File Ref: DA201500081

### **Synopsis**

This report concerns an application under Section 96(2) of the Environmental Planning and Assessment Act 1979 to modify Determination No. 201500081, dated 28 October 2015, to re-configure the internal layout of the building, construct an additional storey to Building A and Building B and an increase to the finished floor level of the eastern portion of Building B by 200mm to accommodate the approved substation.

*Image 18: Previously submitted elevational shadow diagrams for 793-799 New Canterbury Road under the original application (Scenarios SA4-SA6)\*\**

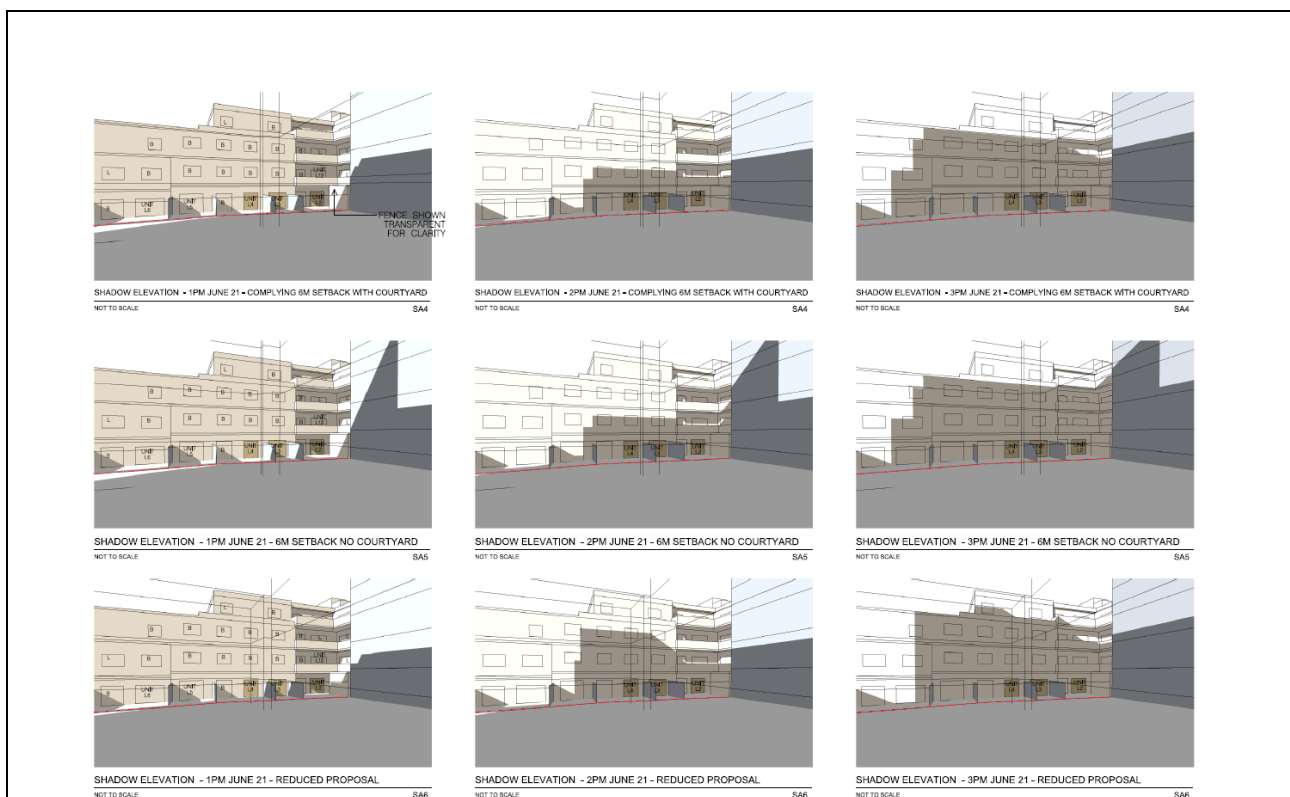
The shadow diagrams submitted with the application illustrate the extent of overshadowing on adjacent properties. The site has a north-south orientation, as such will cast a shadow on the residential dwellings at 793-799 New Canterbury Road (located to the east of the site). No residential buildings are located to the west of the site and as such are not required to be considered in this regard.

- No shadow will be cast by the modified development on 793-799 New Canterbury Road between 9.00am to 12.00pm during mid-winter.
- Compared to a compliant development, identical overshadowing impact (being nil impact) will result at 1.00pm;
- A similar impact will occur to the windows at 2.00pm and 3.00pm;
- A similar impact at 3.00pm would occur; and
- The impact is consistent with the overshadowing impact that has already been approved.
